City of Phoenix
PLANNING & DEVELOPMENT DEPARTMENT

RE: Z-78-08 - Jackson Street Entertainment District PUD, Minor Amendment Request

BALLPARK APARTMENTS

PRELIMINARY SITE PLAN

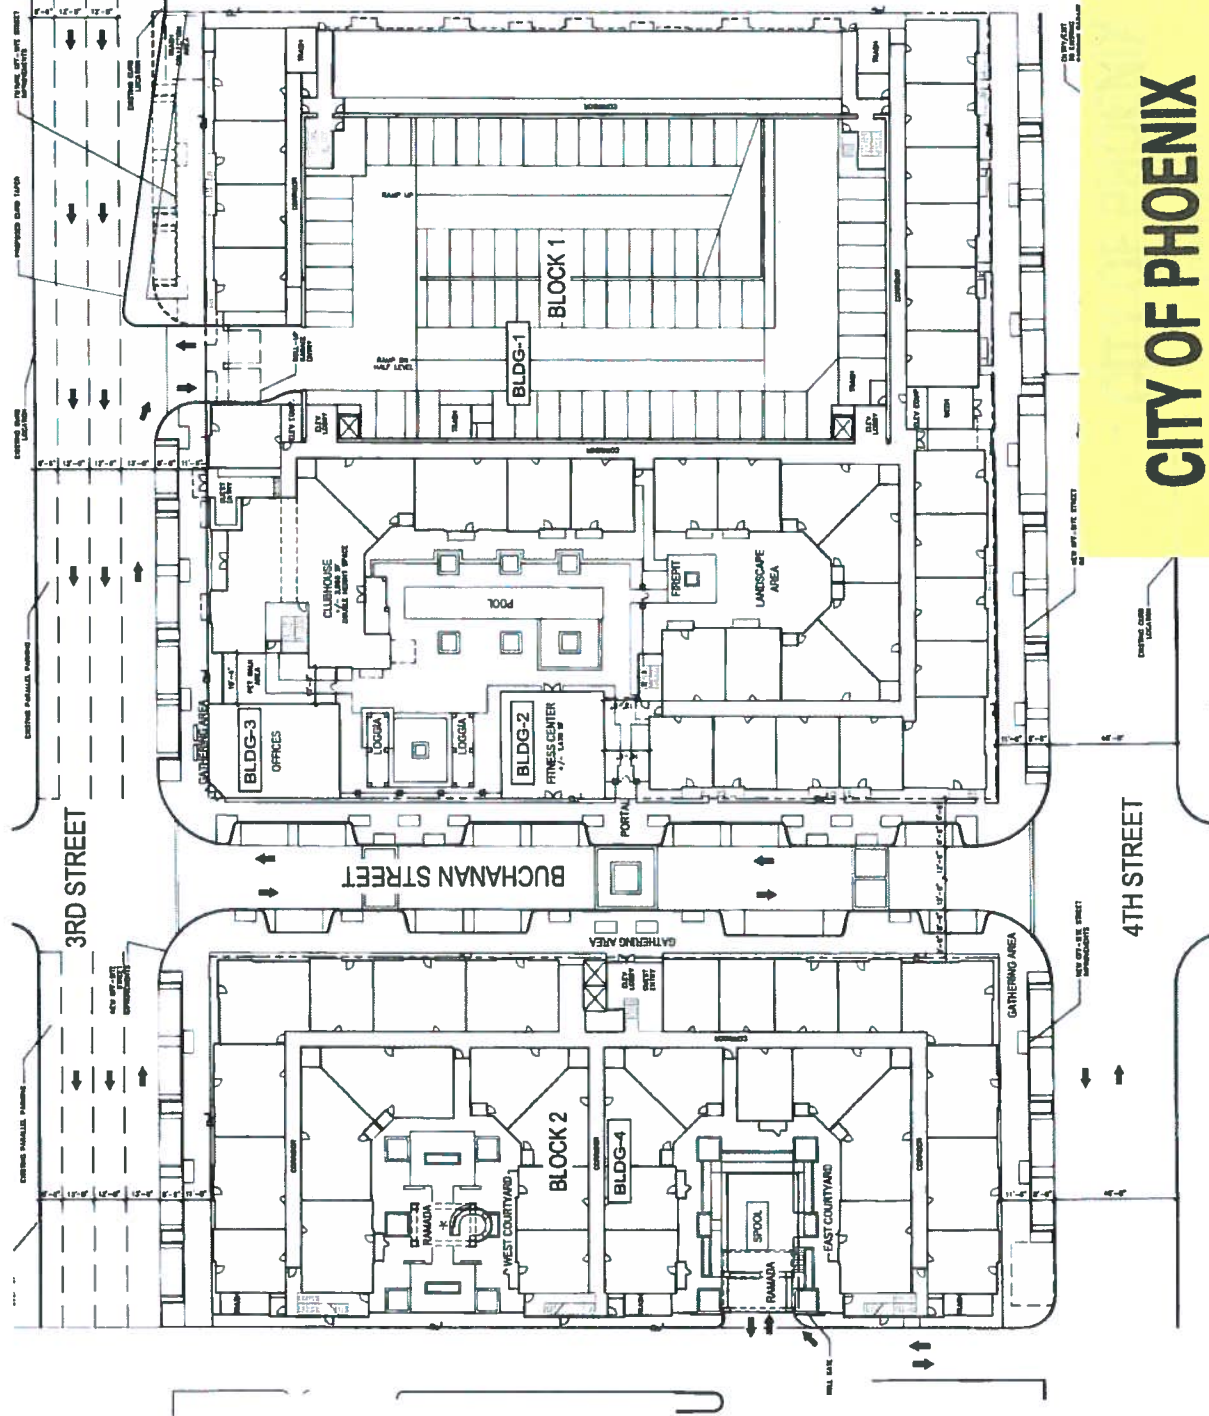
2. Replace the requirement for 15% open space (Section G., p. 19) with the commitment to open space and amenities outlined in #1, above and per the site plan dated September 17, 2013 and email dated November 13, 2013.
3. Define proposed gathering areas (Section G., p.23) as the open space areas provided on the site plan dated September 17, 2013 for north and south of Buchanan Street, as well as three public gathering areas within the right-of-ways at 3rd, 4th and Buchanan Streets.
